Appendix 11

Barton Greenway Review

Nigel Brigham & Associates

Cambridgeshire
County Council

- Option i.** On road route along Grantchester Road.
- Option ii.** New off-road route following Grantchester Road.
- Option iii.** Existing permissive route on Grantchester Meadows

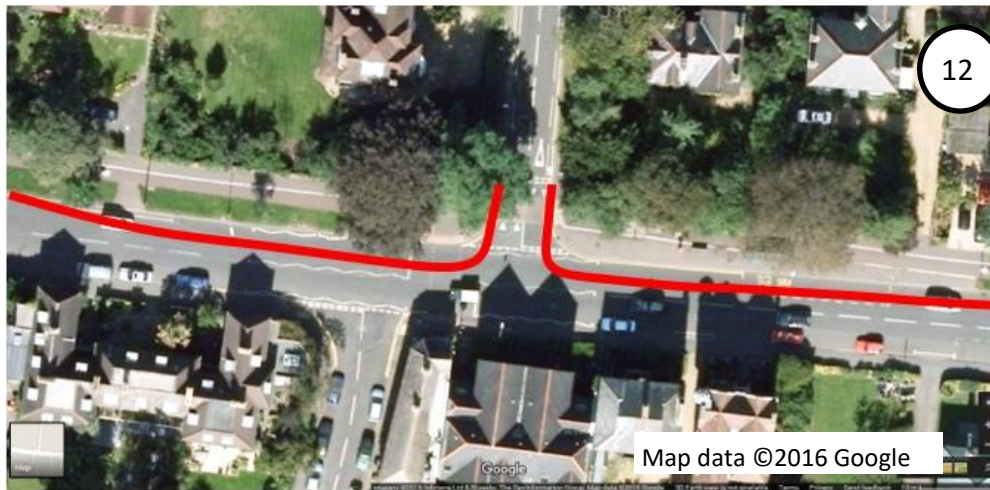
The three options considered are indicated on the adjacent plan. Whilst Option iii is the established route it is recommended that a new route is developed following the Grantchester Road. This has the advantage of developing a route that is better suited for commuting than Option iii. (shown right), whilst relieving pressure on the existing path. The existing path could be widened and this would be relatively easy in places, but challenging elsewhere.

For Option i. to be suitable changes are needed to Grantchester Road. The possible point closure of the road would bring significant benefits but will need detailed consultation. The road is not busy, apart from at peak times, but the nature of the road means that even low traffic volumes can be off-putting for non-motorised users. If a point closure were to go ahead the location would need to be agreed, but in the vicinity of the sports fields is an option. Any closure would need to allow buses and emergency services through. *Option i. with a point closure of Grantchester Road is recommended.*

A more expensive option than point closure would be to construct a new path following the road along field and sports field edges (Option ii). This is an alignment that people are using and would need the agreement of a number of landowners together with some changes to ensure that the route did not interfere with College Sports Fields activities. Option ii should be achievable subject to agreement and funding.

- Barton Greenway Map 3**

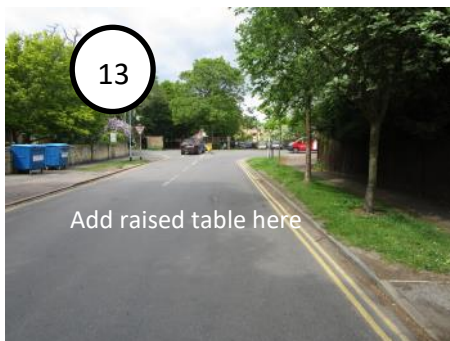
11. Generally the route along Barton Road is of good quality, crossing side roads on raised tables.
12. Grange Road is the most difficult of the crossings along this stretch of Barton Road. It is a busy road and options have been limited, but the City Centre Access Proposals suggest a possible peak time closure of Grange Road. This means that installing signals at the junction is a realistic option. A better alternative would be to move the give way lines forward and move the path away from the properties and into the carriageway to improve visibility and make it easier for cyclists to pass behind cars waiting at the junction. In order to do this it would be necessary to remove some of the car parking and realign the kerb. Removing car parking needs to be considered as part of the City Centre Access Proposals. *Remove parking near junction and realign path at junction, as below.*

- **Barton Greenway Map 4**

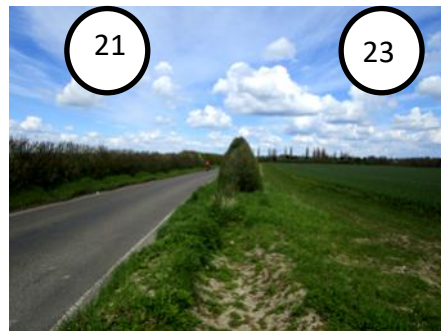
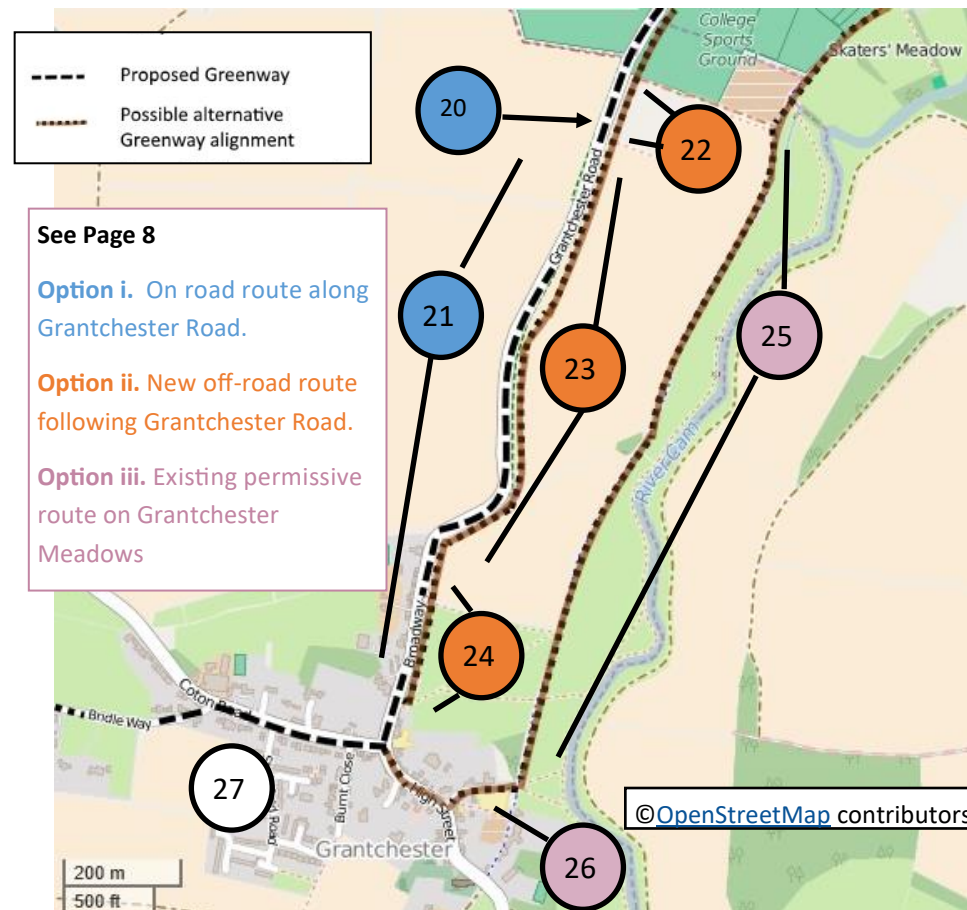
20. The best place for a point closure will need more consultation. A possible location is just to the south of the St Catherine's College Sports Ground entrance so that the entrance can be used as a turning point, although the gates may need moving back. *Close road to through traffic at suitable location.*

21. Route on road on Grantchester Road then Broadway.
22. Alternative route, (if road closure not favoured) along edge of St Catherine's College Sports Ground, subject to College agreement.

23. Existing permissive unsurfaced route along field edge. Would need surfaced path if preferred option. An informal link with St Catherine's land is already established.

24. There is at present no route following the road in this area, but it is possible subject to landowner's agreement.
25. Narrow path 1.2m to 1.5m would need widening to 3m min, if preferred option.

26. Route enters Grantchester on unsurfaced track, by Red Lion. Would need surfacing if preferred option.
27. Route on village roads.

• **Barton Greenway Map 5**

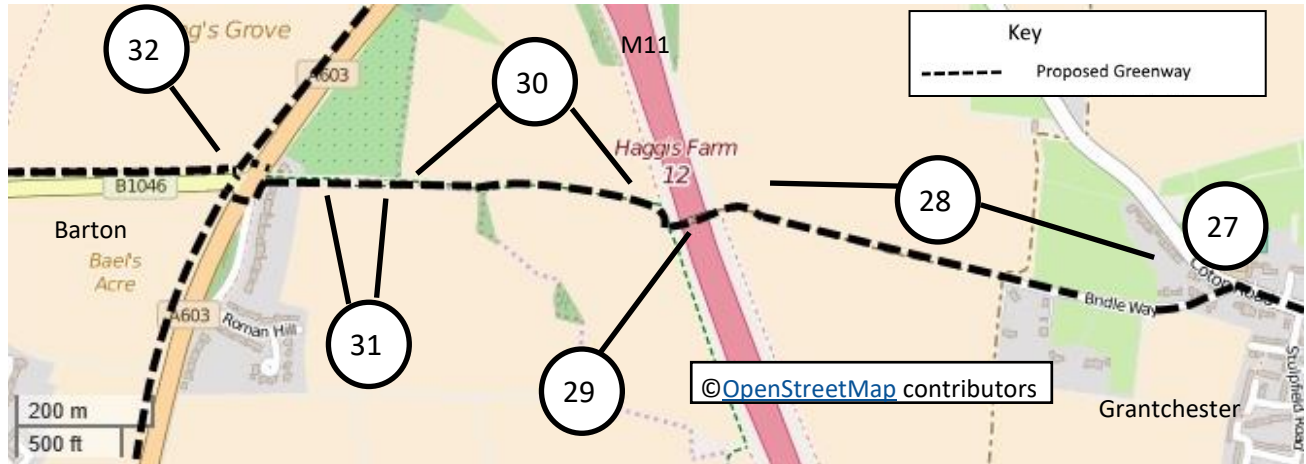
- 27. Route on village roads.
- 28. Farm track / bridleway. A good base but loose and *needs surfacing to 3m.*
- 29. Very good crossing of M11 on bridleway bridge. This was considered as an option for Haslingfield Greenway but is a significant diversion from Haslingfield and was discounted.
- 30. Path is 1.8m wide with loose surfacing. *Surface to 2.5m with sealed surface.*

- 31. The path divides into 2 parts and then passes between hedges as it approaches Barton. *Widen path as much as possible and to at least 2m by removing segregation and surface with a good even surface to replace the existing.*
- 32. The bridleway meets the A603 almost opposite New Road and near Roman Hill. There are paths on the opposite side of the main road and generally linkages are poor. There is a central refuge with guard railing that is 1.8m wide, but the whole area needs reviewing. *A new continental geometry roundabout to reduce traffic speeds, make it easier for cyclists (and if appropriate and possible horse-riders) to cross and easier for joining traffic is recommended (see left).*

- **Barton Greenway Map 6**

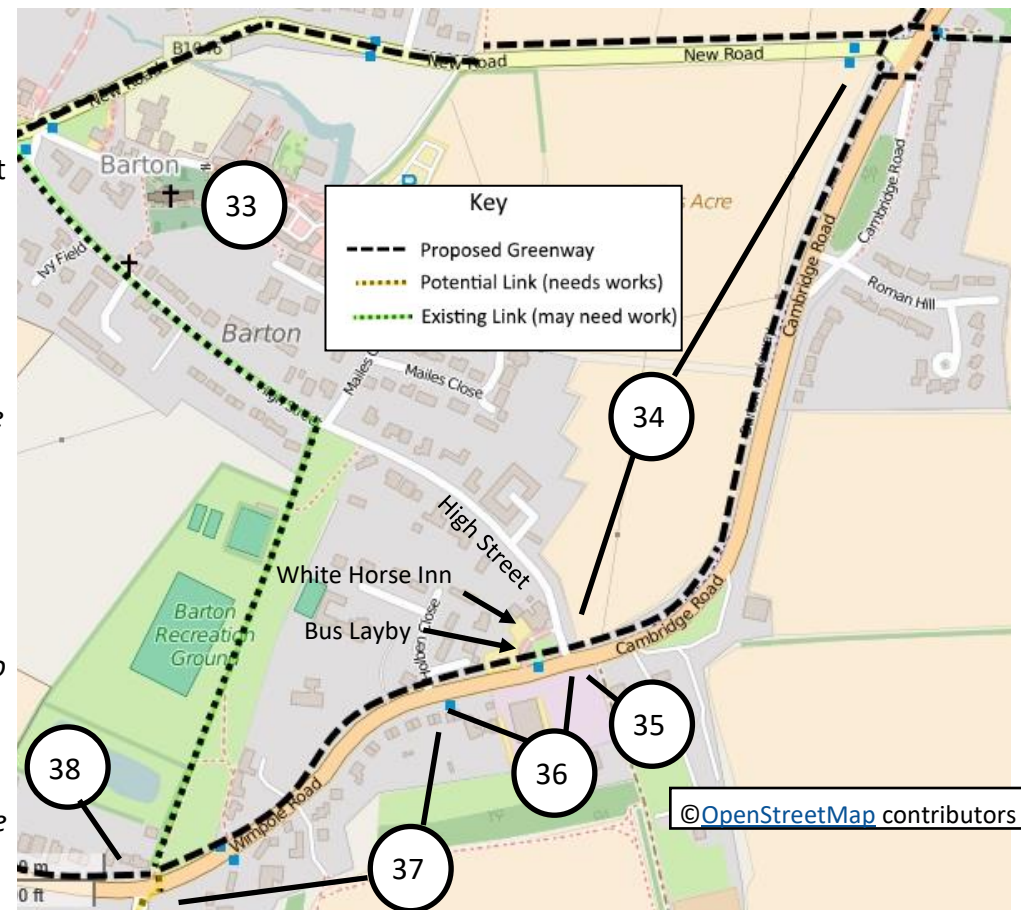
33. For route along New Road and through village centre see notes later.
34. Existing path 2m wide set back from carriageway.
35. The existing route currently stops at the High Street meaning a significant part of the village cannot access the existing path to Cambridge and those beyond the village have no access. *Tighten road junction and construct swept path across the road set back from the junction.*

36. Space is restricted in front of the White Horse Inn but there are opportunities to construct a good path 2.5m wide + 0.5m verge. *Remove bus layby and make bus stop in road. Relocate bus shelter and relocate the edge of the carriageway by removing central hatching to allow good path to be constructed to Holben Close.*

37. *Between Holben Close and the Haslingfield Junction cut back vegetation and relocate the edge of the carriageway by removing central hatching to allow good path and verge to be constructed. Relocate speed camera.*

38. For link to Haslingfield Road. *Tighten junction and move carriageway south into bus layby, with bus stop in carriageway to allow central refuge and safe crossing to be constructed.*

- **Barton Greenway Map 7**

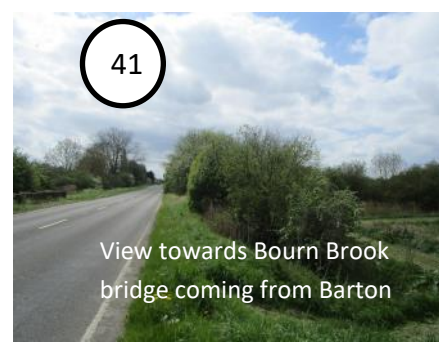
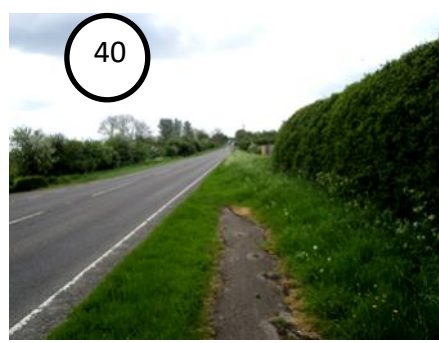
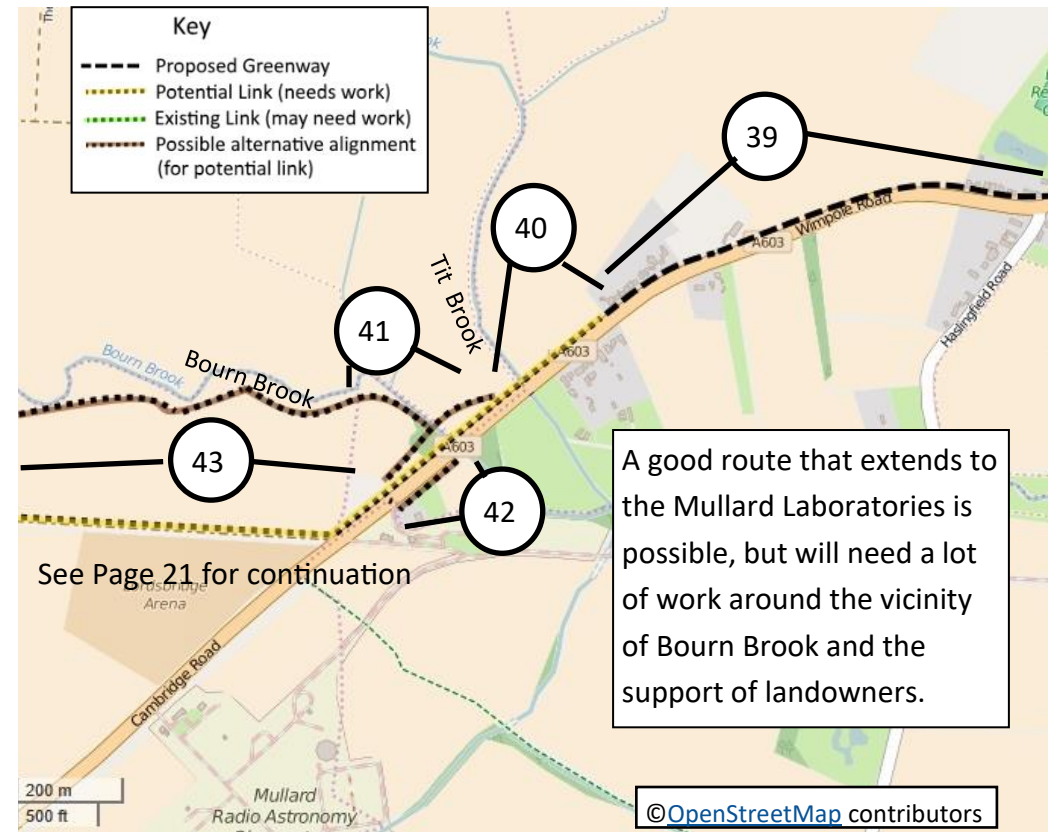
39. From near Haslingfield Road to the last housing in the village there is a narrow path within a wide verge. *Widen path to 2m minimum keeping well away from carriageway edge.*

40. There is space in the verge to continue the path beyond Tit Brook. *Construct new path in highway verge to beyond Tit Brook.*
41. Between Tit Brook and Bourn Brook space in the highway verge becomes more restricted and a field edge path would be a better option, subject landowner's agreement. The aim is to develop a route that continues at least as far as the University buildings. There are a number of options including moving the whole carriageway south-east. *Construct a path that links with Mullard Laboratories entrance .*

42. An option would be to cross the road at Bourn Brook and construct a path on the south-east to reach the University buildings.
43. For onward link between the A603 corridor and the Eversdens landowner's agreement will be needed to construct a field edge path. The best alignment would follow the disused railway/ radio telescope alignment, but there are alternatives. *Construct path between Royston Lane and A603, subject to agreement.*

- Barton Greenway Map 8**

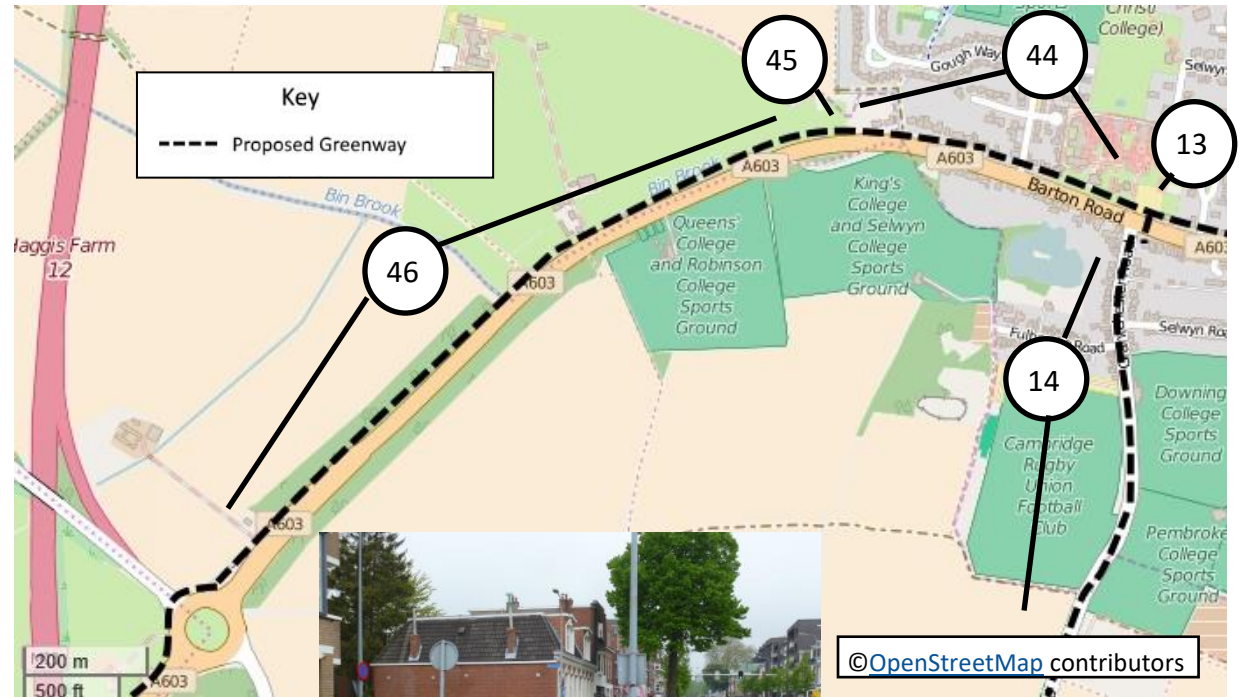
13. Existing toucan crossing. *Widen path around corner for link to Grantchester Road and construct raised table in Grantchester Road for users to join/ leave the carriageway.*

14. Route on road on Grantchester Road. *Designate road as 20mph.* Road can be very congested at peak times and does not work well.
44. The path crosses side roads on raised crossings, but with give way markings at all junctions. *Consider ways to change priorities as in the Dutch example to the right.* It would be timely to revisit these particularly in the light of lessons from Hills Road and other city schemes in recent years. The path is busy at peak times. *Look for suitable opportunities to widen.*

45. Within the built up area the path is segregated and shared use beyond the built up area.
46. Path in highway verge 2m wide generally with verge but in places with no verge. Path in poor condition *needs bringing up to good standard.*

- Barton Greenway Map 9**

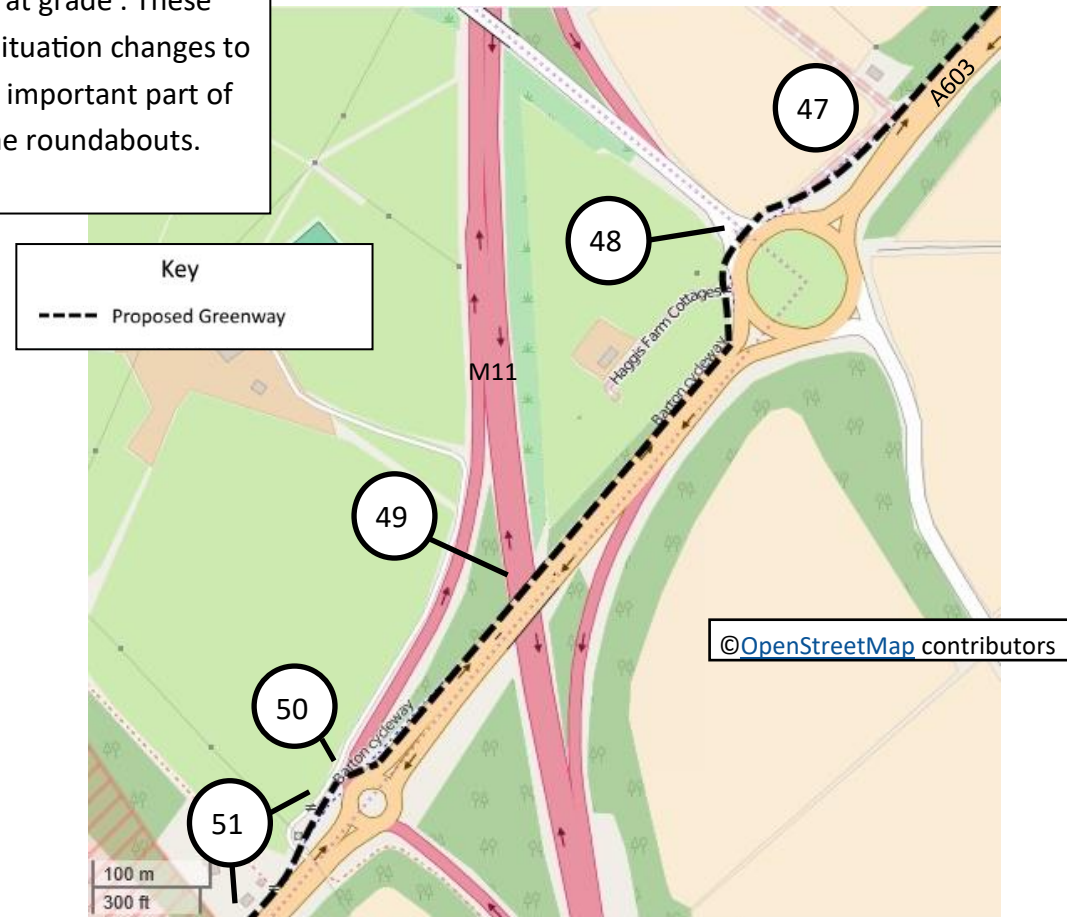
- 47. Path is set well away from the carriageway and crosses private farm road before junction.
- 48. Crossing of roundabout arms. *Re-align approaches and exits to roundabout. See following page.*
- 49. Existing narrow path over motorway. Path is 1.4m wide and parapets are 1m high and therefore not up to standard. *Reposition path into carriageway by reducing carriageway to single lane and designating one lane as a two way cycle route.*
- 50. Crossing of slip road, where speeds can be high. *Re-align slip road see following page.*
- 51. Path in poor condition and overgrown at time of visit. *Path needs rebuilding and re-aligning.*

Crossing of Roundabout (east) ref 48

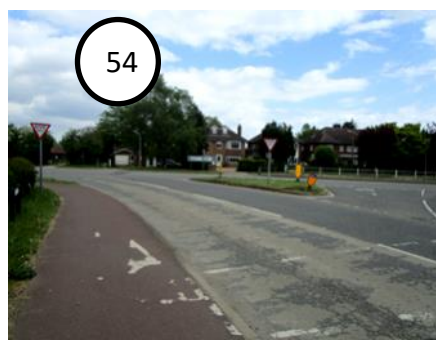
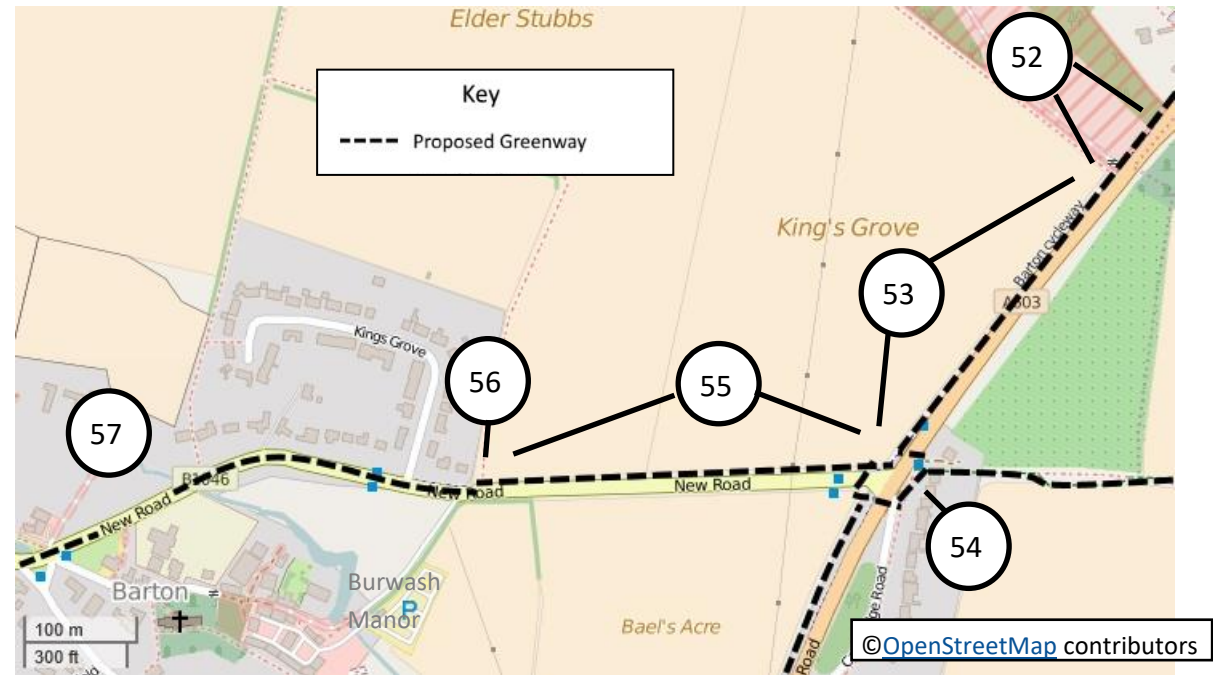
Any changes need to address two major issues:

1. Improving the crossings of the exit and entry arms of the roundabout for the Greenway.
2. Provide options for other movements particularly those heading to or from Grantchester and Coton.

The proposal is sketched above and is to replace the existing roundabout with a Dutch style “Turbo” roundabout to reduce speeds, improve lane discipline and improve visibility whilst re-aligning the entries and exits to the roundabout to improve crossings. Paths have been shown to help cyclists using the roads to navigate around the roundabout and a suggested additional path to link with the Coton road beyond the M11 slip road. (Not surveyed).

- **Barton Greenway Map 11**

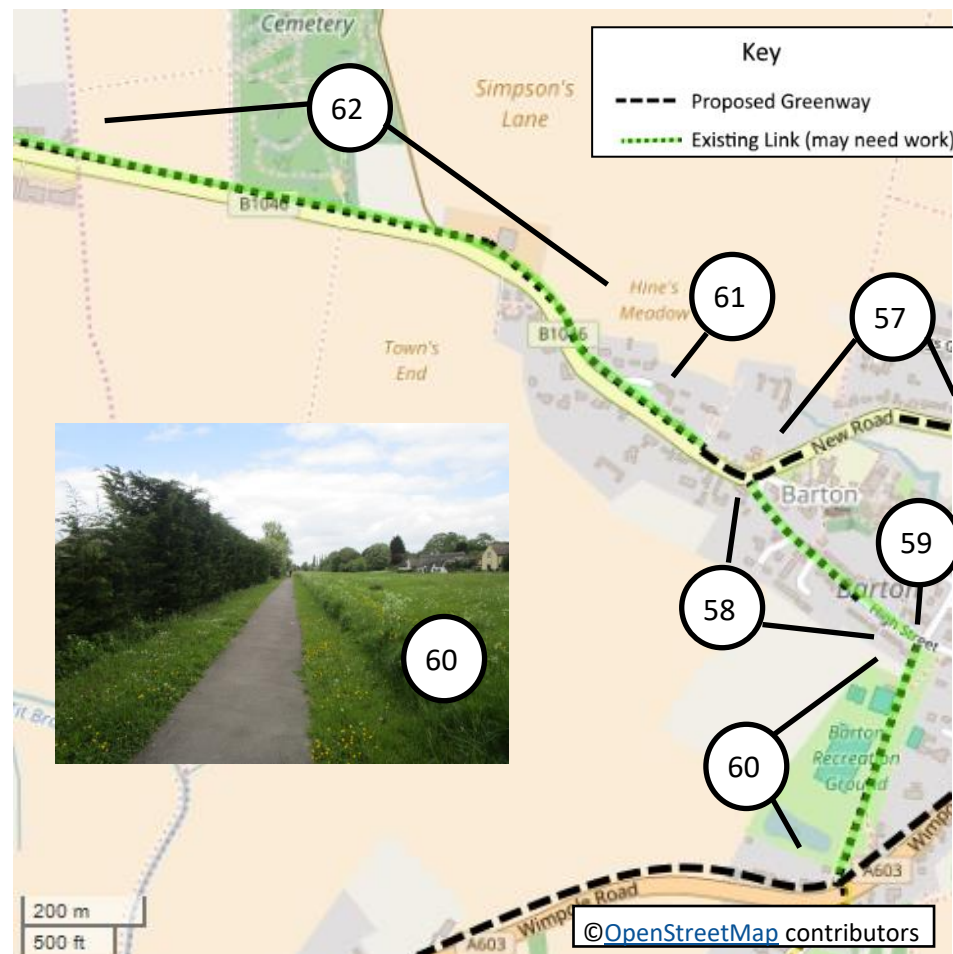
57. Designate road through village centre on New Road, as 20mph.
58. Designate road through village centre on High Street, as 20mph.
59. Tighten up High Street/ Mailes Close junction and add cycling zebra crossing by entrance to Recreation Ground.

60. Path through Recreation Ground is a useful link. The path is currently 1.5m at the southern end and 1.7m at the northern end with ample verges. Consider widening to 2m, but a lower priority than route to Comberton.

61. Construct raised table at suitable location for on road route to join off-road route. Widen path on highway land to join up with existing path. The existing shared use path ends just beyond a layby. It can be extended beyond the layby, but perhaps more importantly the route should join the carriageway in an obvious manner.

62. The existing path is generally 1.5m wide, so would need widening by at least 0.5m with a verge adding where possible. There are some constraints such as a bus shelter but improving the route would be very valuable. *Widen path to 2m minimum and add verge where possible. Add solar studs.*
